# MEMO

**Subject: Approve \$600,000 of Additional Funding to Amend the WMD-AWPF Medium Voltage Project Budget from \$3.89 Million to \$4.49 Million for Design Modifications to Develop MicroGrid Capabilities for this Electrical Connection**

**RFQ 002: Switchgear Modifications for Island Mode Operation**

**MIRWMD TO AWPF MEDIUM VOLTAGE SYSTEM**

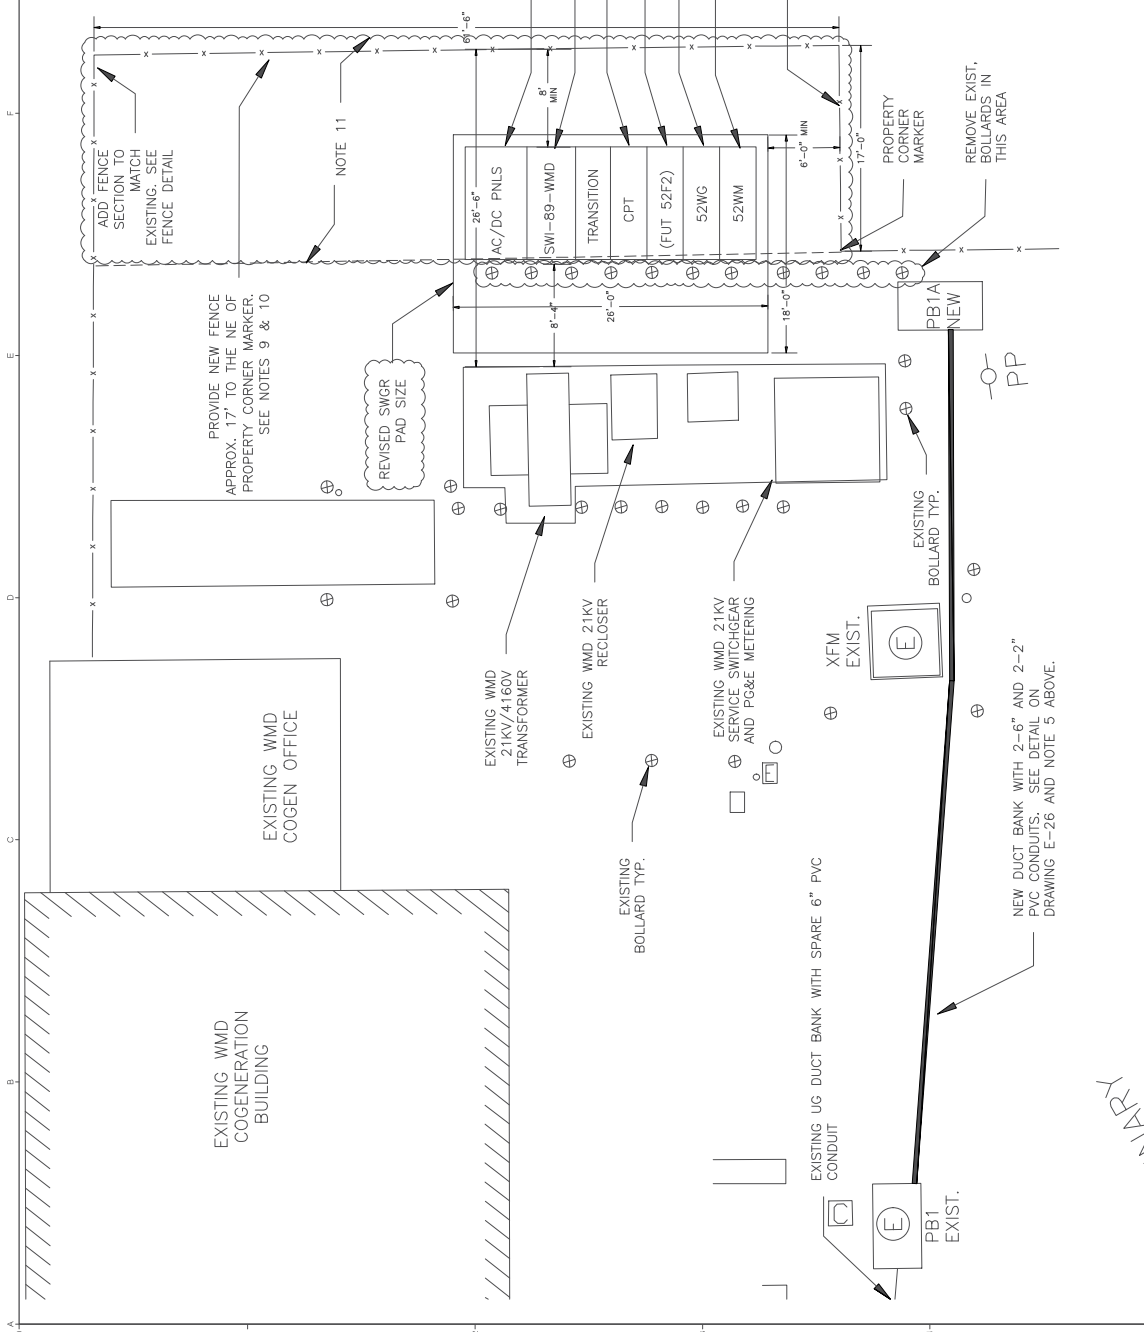
The District would like to modify the switchgear to accommodate Island Mode Operation. Island Mode Operation would allow the District cogeneration units to continue to operate to supply power to the AWPf when PG&E service is no longer available. This work is contained to the switchgear and will not impact equipment owned by PG&E.

Please see the attached switchgear single line diagram and site layout drawing showing revisions to accommodate Island Mode Operation and the description of the work to be done below.

- 11) Provide a larger concrete pad to accommodate the large MV Switchgear required per the above. Coordinate with Eaton on final switchgear size. Provide a pad with additional 1 ft on each side of and behind the switchgear.

WMD 21KV SWITCHGEAR SINGLE-LINE DIAGRAM

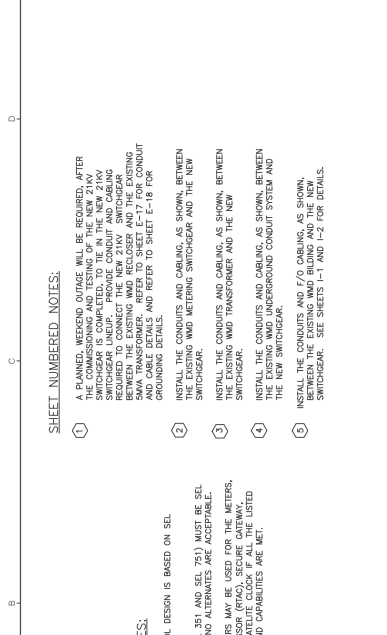
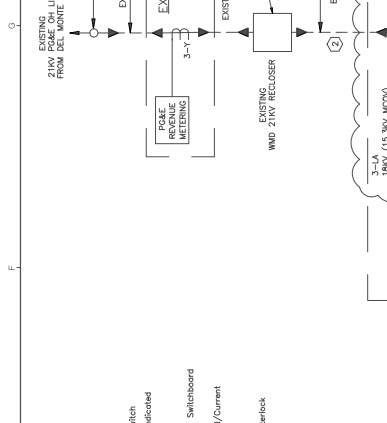
- 1) Add a new cubicle, Cubicle 6 21kV Main Circuit Breaker, to the right side (viewing from the front) of the MV Switchgear lineup next to Cubicle 5 21KV AWPf Feeder Protection and Control.

- 2) Remove the 21kV Switch 89-Site Cubicle from the MV switch equipment.
- 3) Relocate Line PT's, incoming Arrestors, incoming metering CT's, incoming SEL 735 meter and all associated control equipment to the Cubicle 6 21kV Main Circuit Breaker to be added.

- 4) Install the relocated Line PT's and Arrestors on the incoming bus to the new Main Circuit Breaker.
- 5) Install the relocated metering CT's on the bus side bushing of the new Main Circuit Breaker.

- 6) Install the relocated SEL 735 meter and associated wiring and control components in the Cubicle 6 21kV Main Circuit Breaker to be added. Connect to metering CT's on the Bus side of the new Main Circuit Breaker.

- 7) Provide 3-new multi ratio 600/200/5 CT's, similar to the ones used on the feeder CB 52WG, on the line side bushing of the new Main Circuit Breaker. Install the 3-new multi ratio 600/200/5 CT's in Cubicle 6 21kV Main Circuit Breaker to be added.

- 8) Provide 3-new PT's, similar to the others used on this project, and install on the switchgear bus and wire as shown on the single line diagram.
- 9) Remove the 2-SEL 351-7 relay from the MV Switchgear equipment.

- 10) Provide 2-new SEL 700G#XNAL relays to replace the SEL 351-7 relays. Install the 2-new SEL 700G#XNAL relays in Cubicle 3 21KV-240/120V CPT, Site and WMD Metering and Communications and wire to the new Main Circuit Breaker line side 600/200/5 CT's.
